# UN No. 73 : Proposal for amendments to LATERAL PROTECTION (GOODS VEHICLE)

UN-R No. 73: Proposal for amendments of provisions on lateral protection devices for heavy-duty vehicles

MLIT, Japan

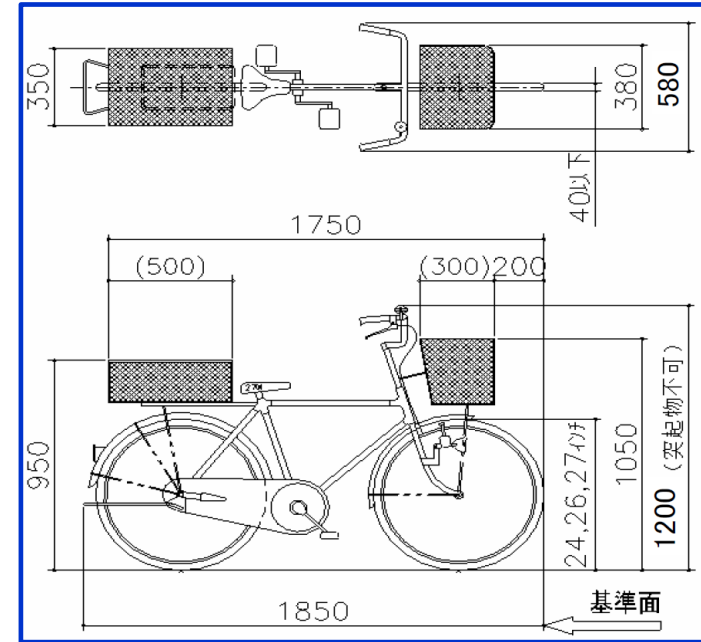
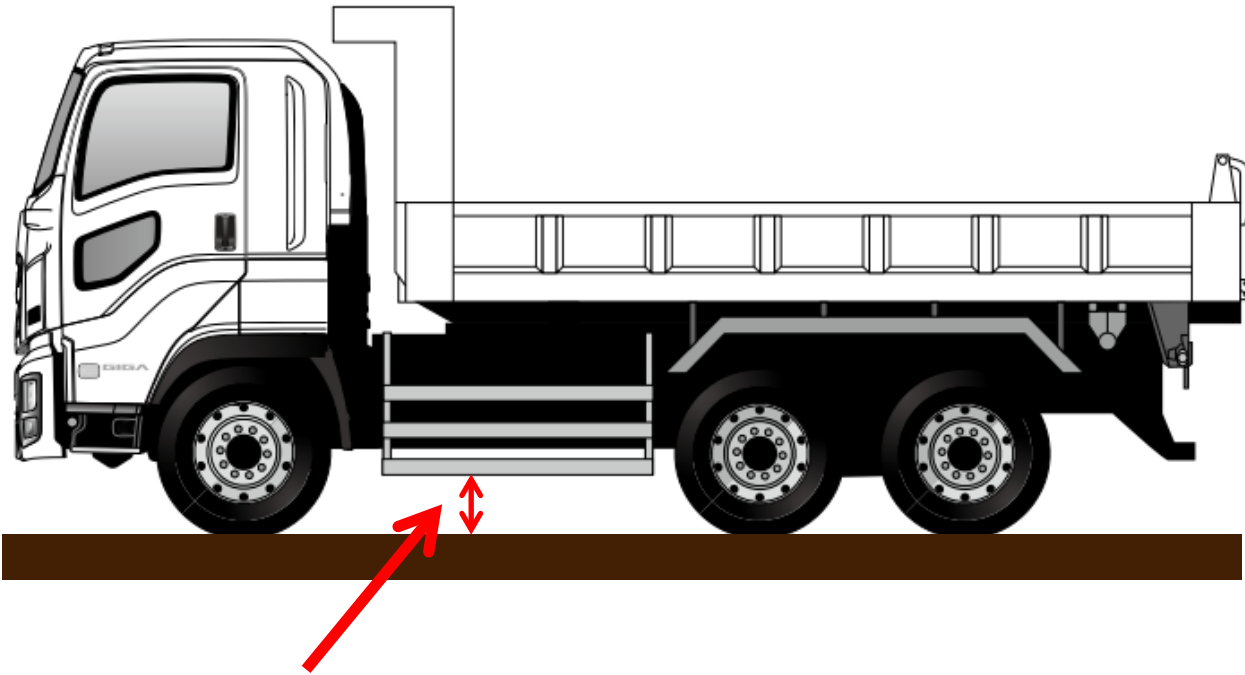
Left-turn\* collisions occur when a truck turns left and, due to its inner wheel difference, catches a cyclist running aside going straight, the cyclist tumbling beneath the LPDs.

The collision with cyclists relates to the lower edge ground clearance of LPDs.

To prevent the cycle structure from diving under the lower part of the LPD when the cyclist fell over, it is appropriate to set LPD's ground clearance to 450mm or less.

**We propose that the ground clearance in Paragraphs 12.8. and 15.6. be reduced to 450mm.**

The lower edge of LPD shall at no point be more than **450** ~~550~~ mm above the ground.

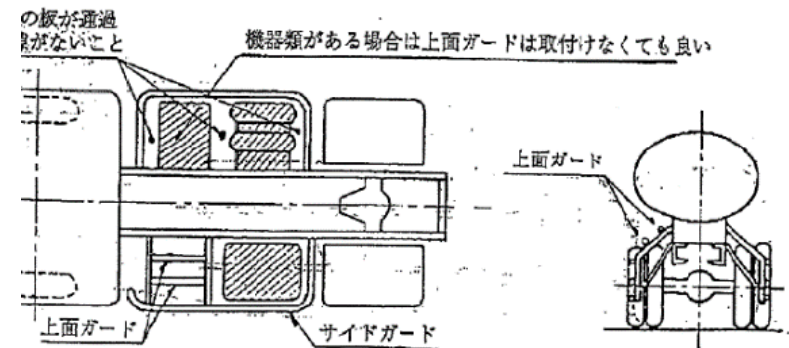
A truck running without a load-carrying platform is dangerous to other road users, because it doesn't have Protector between LPD and chassis frame, which would otherwise prevent them, if collided, from diving under the platform.

When a detachable-type load-carrying platform is detached and absent, it wouldn't be able to, as otherwise it would, prevent a falling cyclist from above with its LPD from tumbling under the chassis.

Without the top guard of LPD, a cyclist may fall inside the LPD and get caught by the rear tyres.

We propose that the structure of the current text be reviewed, because deleting 12.9.3. and 15.7.3. will make the content of 12.9.1-2. and 15.7.1.-2. inconsistent.

12.9.1. and 15.7.1.

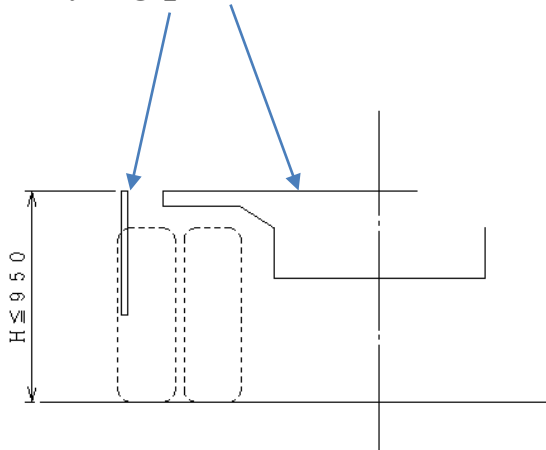
LPD upper edge is the same height as surface of the load-carrying platform

12.9.2 and 15.7.2.

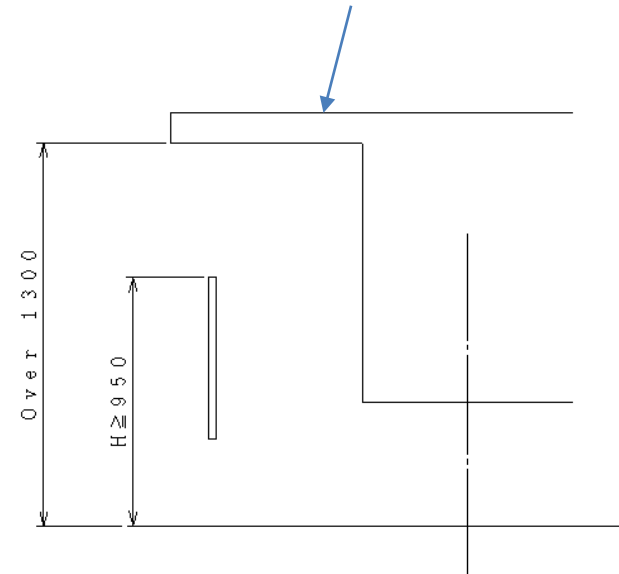
paragraph 12.9. cuts the structure of the vehicle

12.9.1. and 15.7.1.

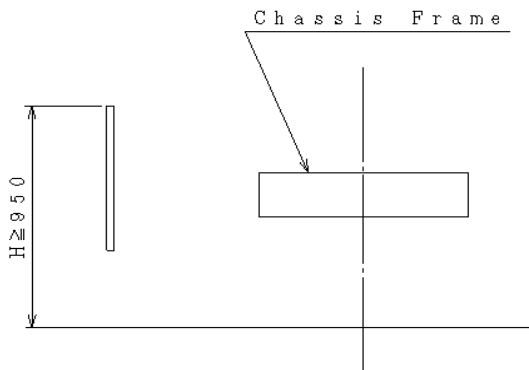
The ground clearance of LPDs might be 950mm.

Where the plane in paragraph 12.9. does not cut the structure of the vehicle or cuts the structure of the vehicle at a level more than 1.3 m above the ground, then the upper edge shall not be less than, 950 mm above the ground.

12.9.2 and 15.7.2.

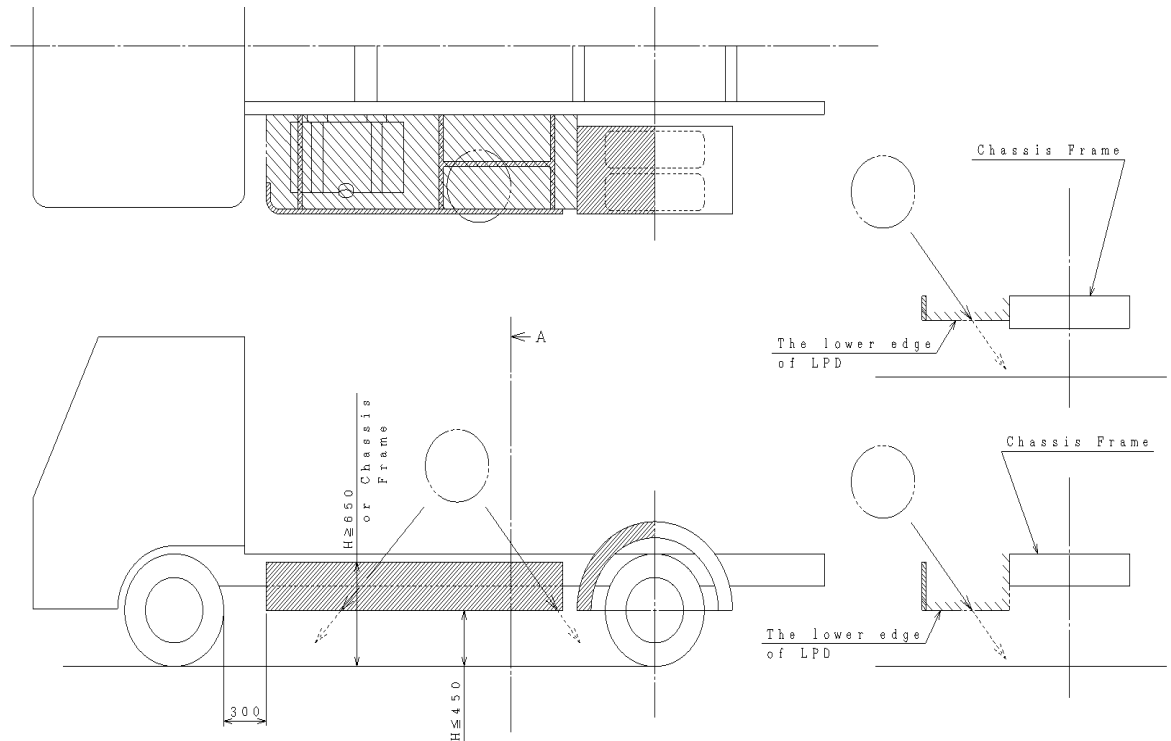
Or, otherwise, a top surface protection might be provided.

The upper edge of LPD is [650] mm above the ground, be level with the surface of the chassis frame, whichever is less, and the structure is designed to prevent cyclists from falling under the vehicle fly over the LPD (see Figure 2 below). The fall prevention shall be demonstrated by the structure not allowing the [450] mm sphere to fall to the ground from the area enclosed by the LPD, chassis frame, and fender. Other methods may be adopted to comply with this requirement if a manufacturer so requests. The sufficiency of the fall prevention method shall be established to the satisfaction of the Technical Service.

### 12.9.2.&15.7.2.

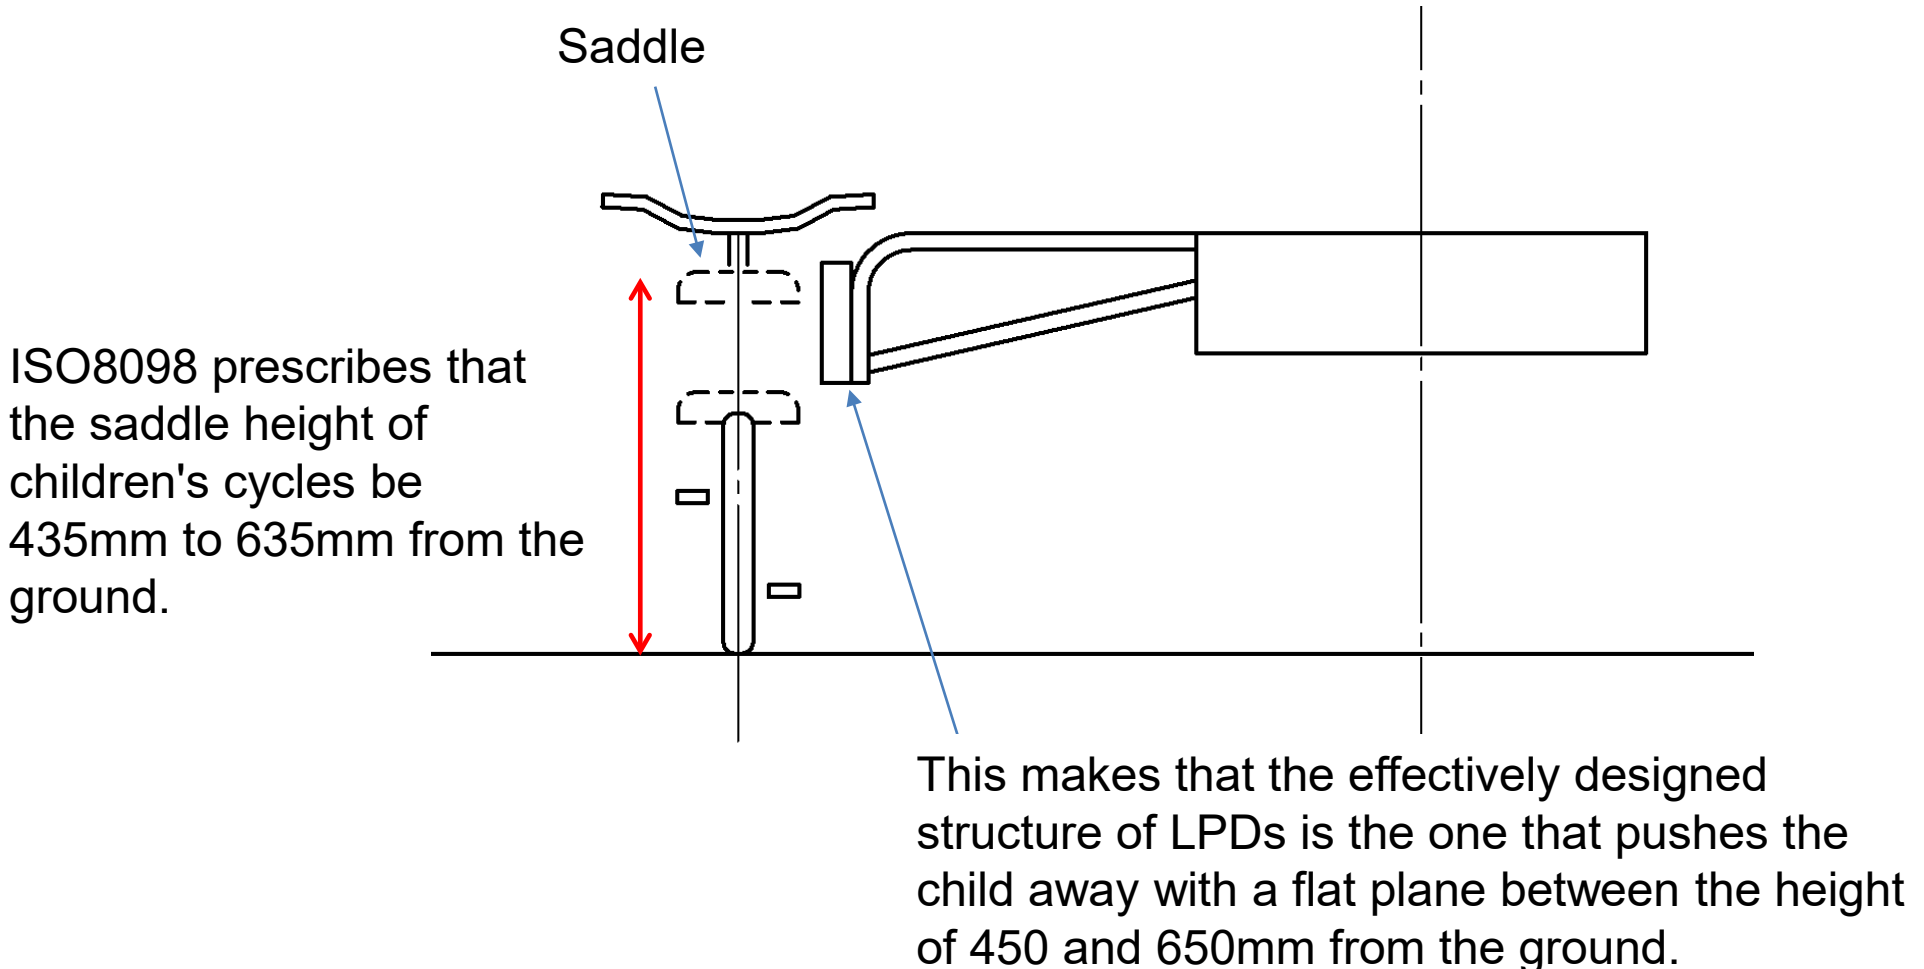
(As to the appropriateness of 650mm and 450mm, we would like to hear your opinions at the GRSG meetings. The grounds for the figures are given on the following slide.)

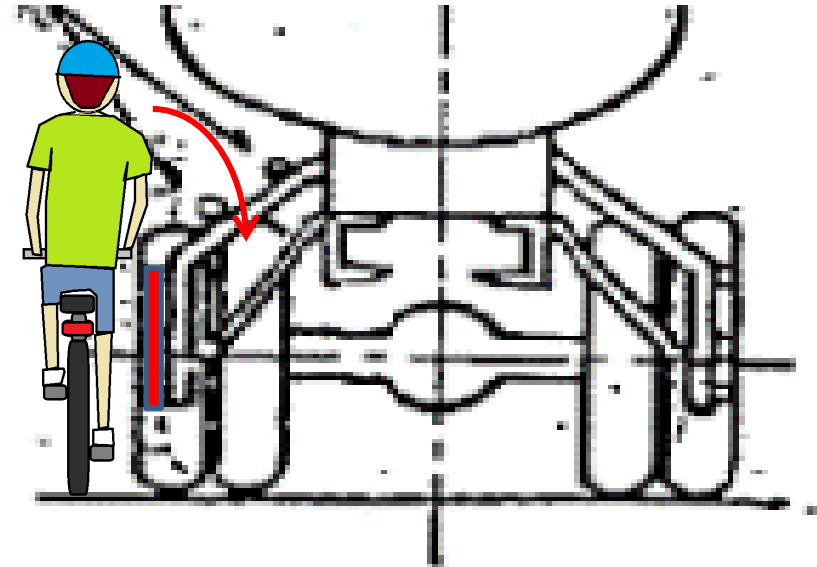
The grounds for the size of the sphere required to prevent cyclists from tumbling beneath the vehicle being 450mm

If the cyclist collides with the LPD in the lower part of the body, they might fly over the LPD to tumble beneath the chassis.

ISO4210 (Cycles -- Safety requirements for bicycles) prescribes that the minimum saddle height be 635mm. If the ground clearance of LPD is too low, there is a risk that a large person may fly over the LPD to tumble beneath the vehicle.

The gap between the LPD and the chassis frame for a person falling between the LPD and the frame not to fall to the ground was set based on the width of an adult male's shoulders.

\*The average shoulder width of a person 180cm tall is 450mm (25% of their height).
